Model: DADF-H1

Ref. No. : FF-T01-X-000041-01

Subject: Addition of a damper to the left hinge unit to alleviate noise generated when closing the DADF

Figure: New type of left hinge unit

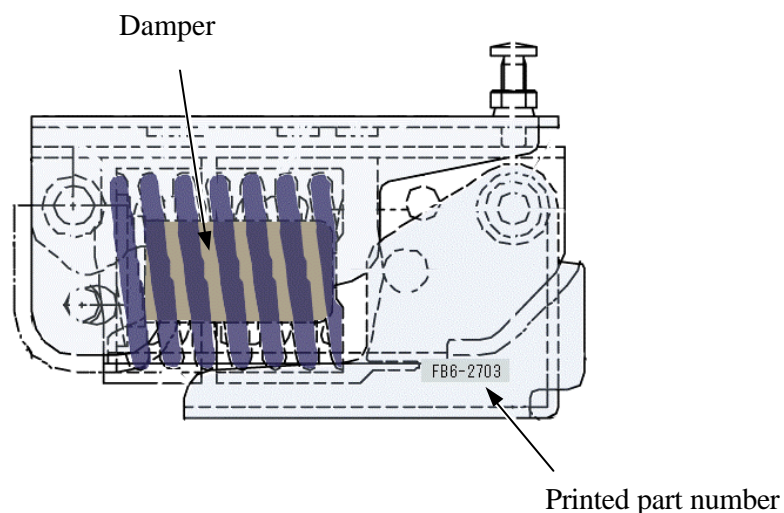
Noise when closing the DADF (Banging noise is created when the DADF is closed.)

Add a damper to the left hinge unit in order to alleviate the shock when the DADF is closed so that the noise can be also alleviated. (See the figure below.)

If you receive a complaint about the noise when closing the DADF, replace the left hinge unit with the new type.
